Mahopac Central School District  
Mahopac, New York

Reconstruction at  
Mahopac High School  
Mahopac Middle School  
Mahopac Falls School  
Bus Garage  
New Pump House

BID Addendum No. 4  
to  
Drawings and Project Manual

March 1, 2021

**4 Subsurface HS Eastern Drainage System**  
N.T.S.

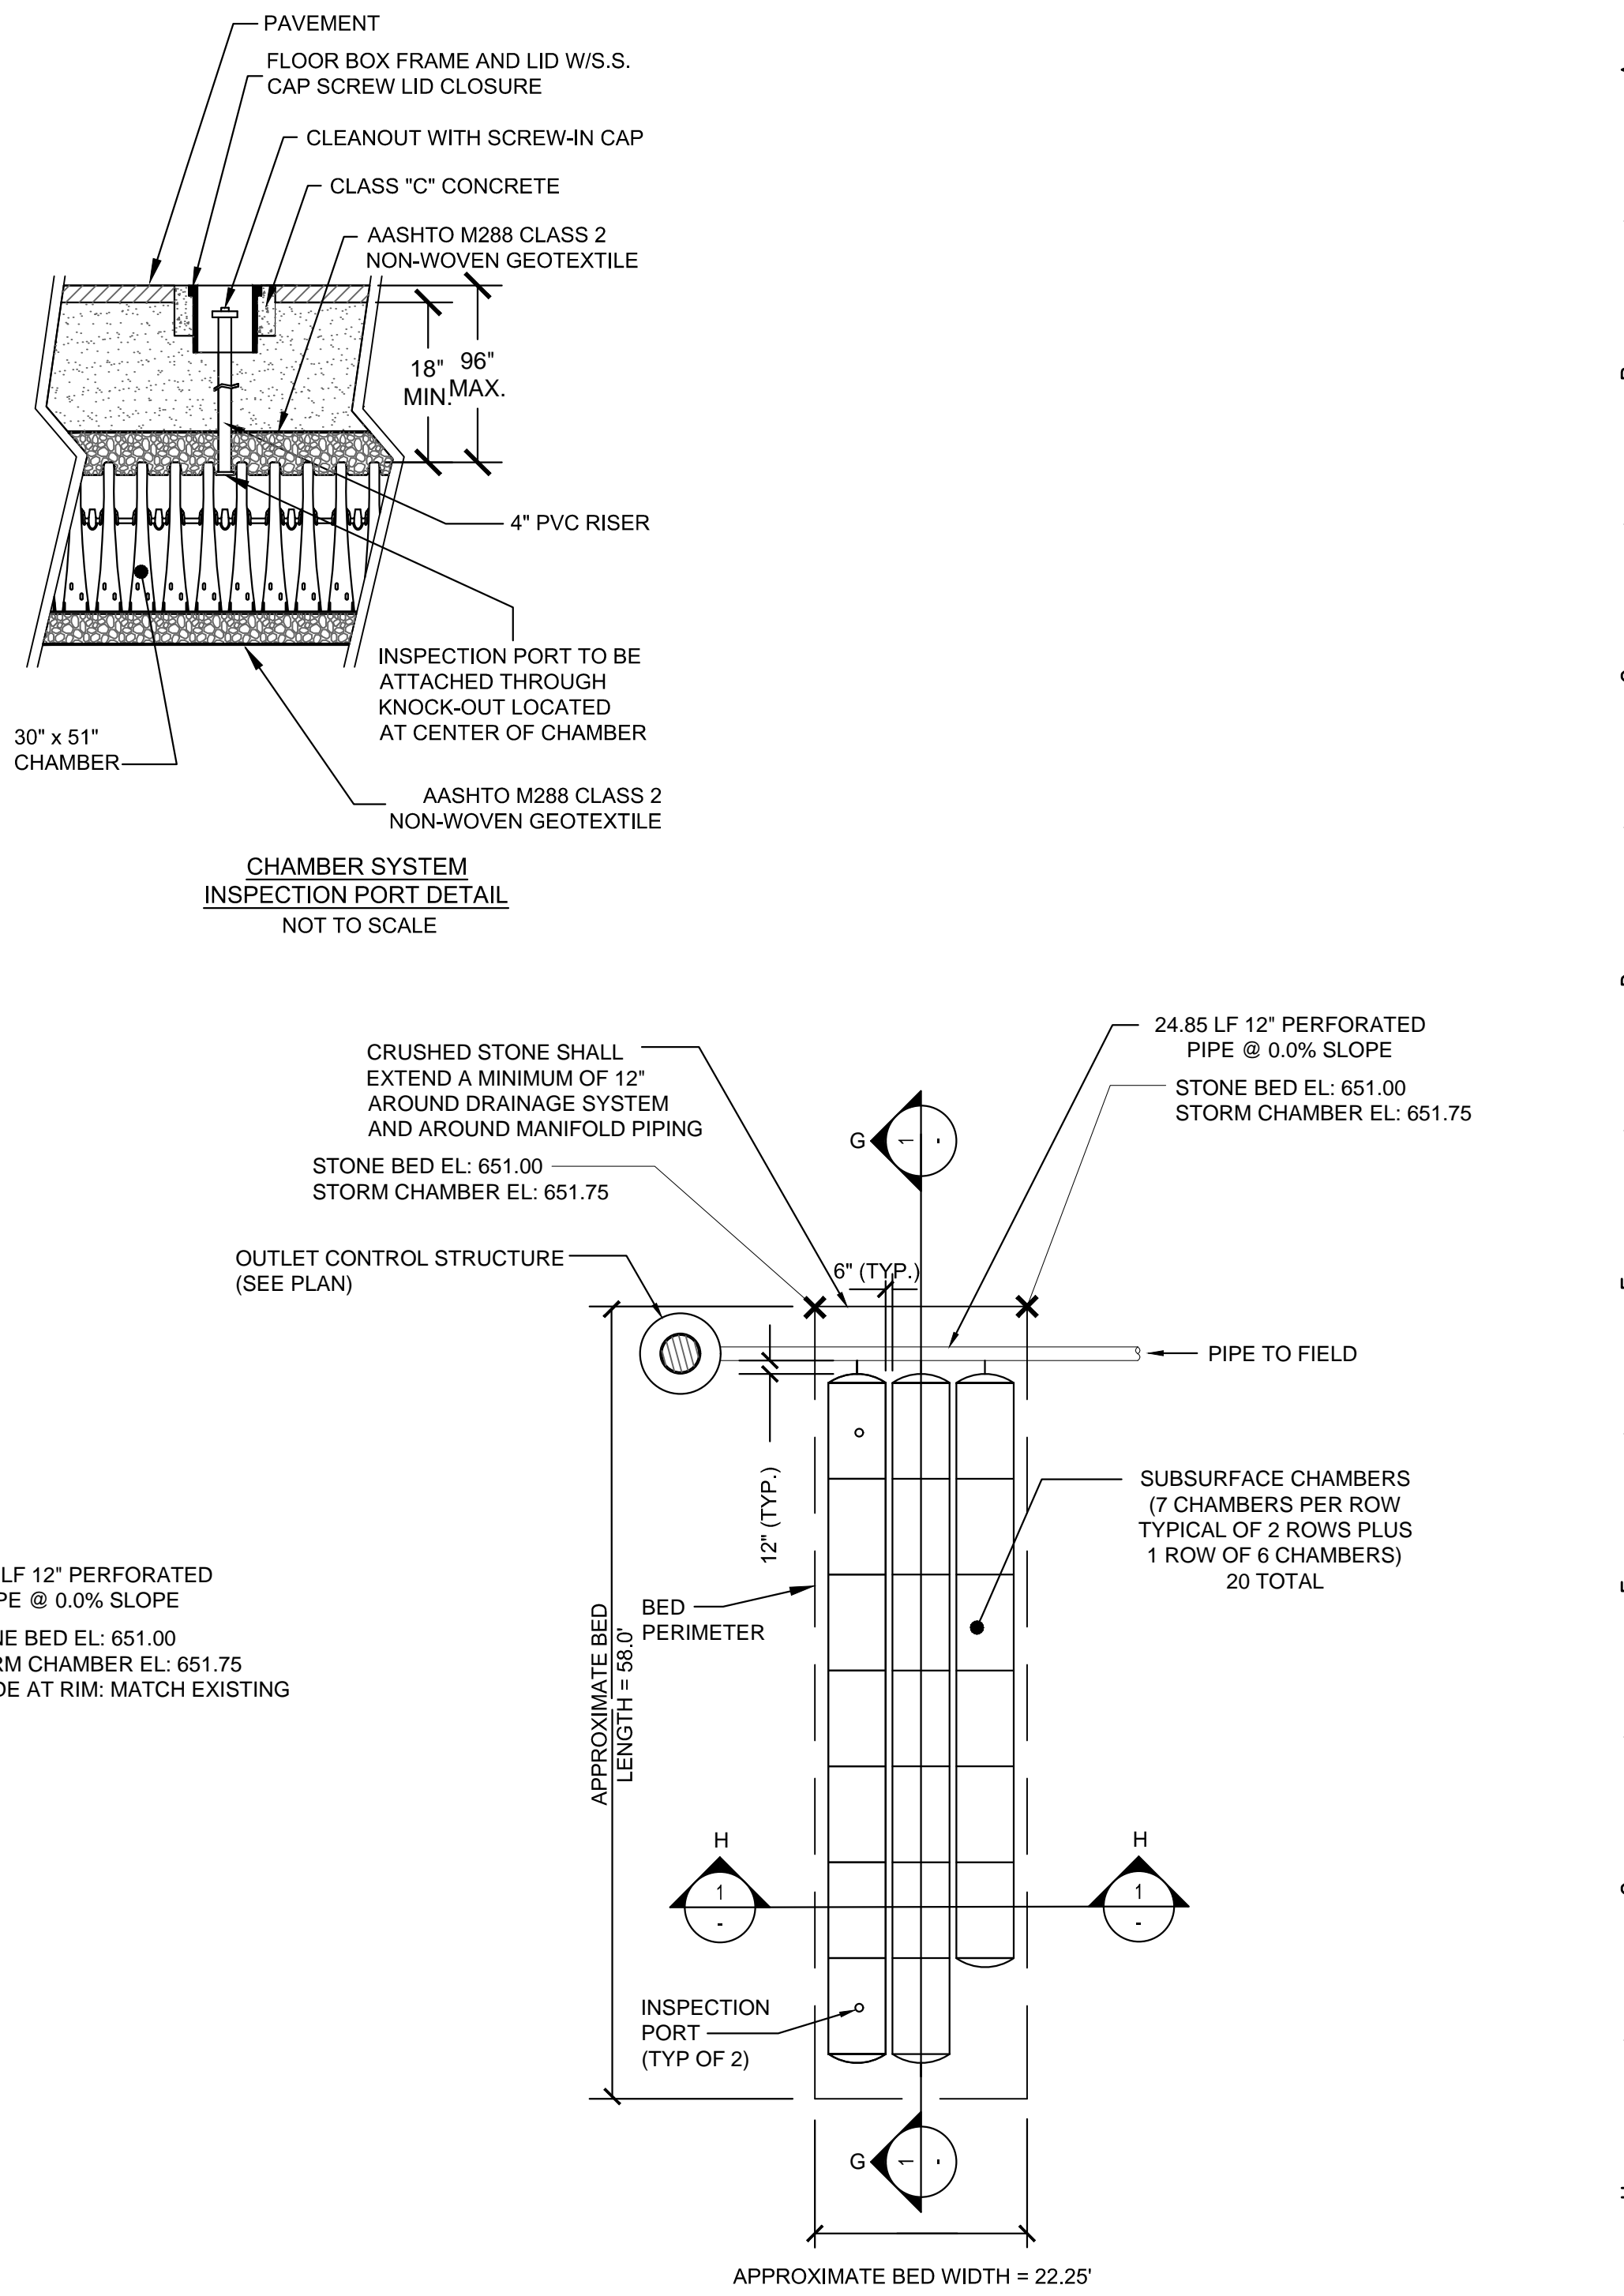
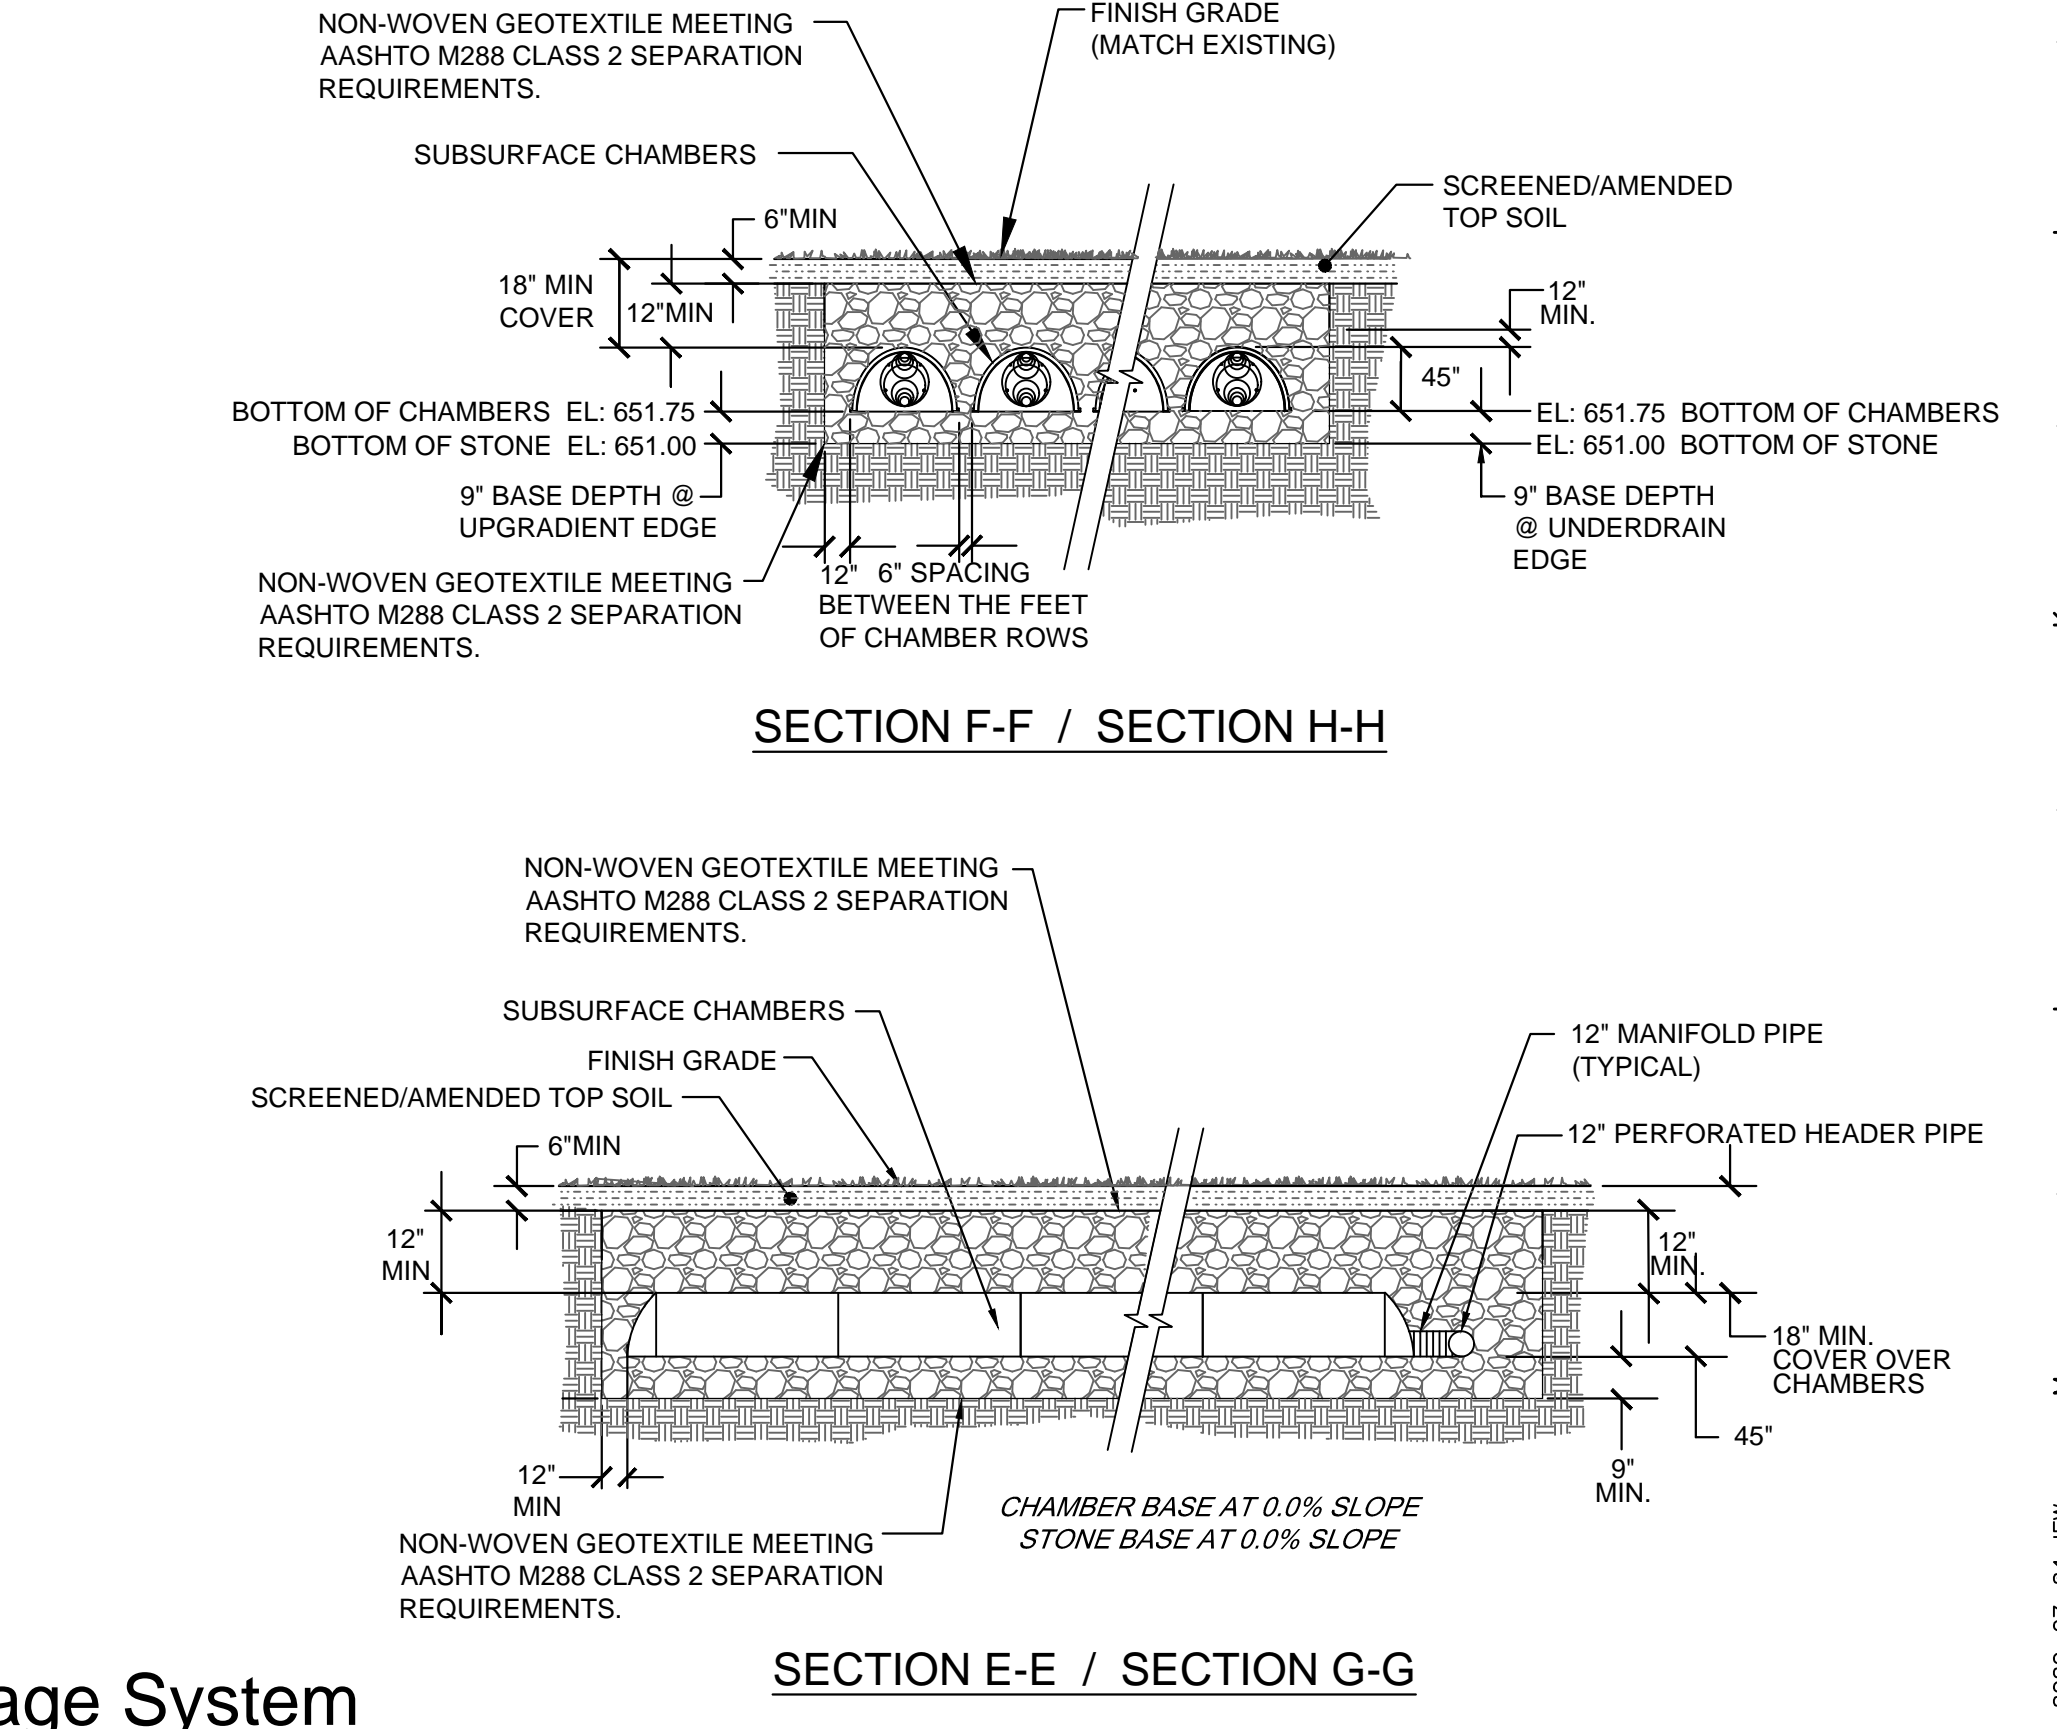
DETAIL 4 ON SHEET CZ-505 SHOWS THE CHAMBER SYSTEMS TO BE A HEIGHT OF 45". WHEN REFERRING TO THE SPEC SECTION, IT SPECIFIES THE CHAMBER TO BE A SC-740 BY STORM TECH. THIS MODEL IS ONLY 30" IN HEIGHT. PLEASE CLARIFY AS TO THE HEIGHT OF THE CHAMBER SYSTEM.

DRAWING # AC-140 SHOWS THE DRAINAGE CHAMBER SYSTEMS ON WEST SIDE.  
IT SCALES (1" = 30' ) TO BE APPROX. 155 LF LONG TO INCLUDE TIE IN PIPES.  
DETAIL SECTION ON CZ-505 STATES THE BASE LENGTH TO BE 110.22 LF  
THE SAME WITH THE EASTERN DRAINAGE CHAMBER SYSTEM. THE SCALE DOESN'T MATCH  
THE DETAIL SHOWN LENGTH. PLEASE CLARIFY ON WHICH DIMENSION TO USE FOR BIDDING.

Refer to forthcoming Addendum #4. Storm chamber systems indicated on revised and reissued Site Detail Drawing ZC505 shall apply.
